WILLIAMSON COUNTY, TEXAS

CHANGE ORDER NUMBER: 3

Project: 1809-261

Roadway: CR 110 Middle

CR 110 (MIDDLE SECTION)
DETOUR LAYOUT
PHASE 2 STEP 2

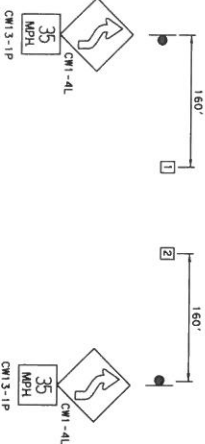
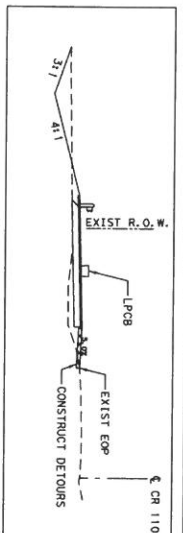
3F: County Convenience. Additional work desired by the County. This Change Order adds Traffic Control Phase 2 Step 2 to the project. This step consists of shifting traffic from the existing lanes to the new lanes from just south of CR 112 to the north end of the project.

Note: The LPCTB shown along the right side of the detour is not necessary since the box culvert has been lengthened which removed any hazards that were protected by the CTB.

We could use WZPM non-removable markings if that is easier and cheaper. Let me know if you have any questions or would like to discuss further.
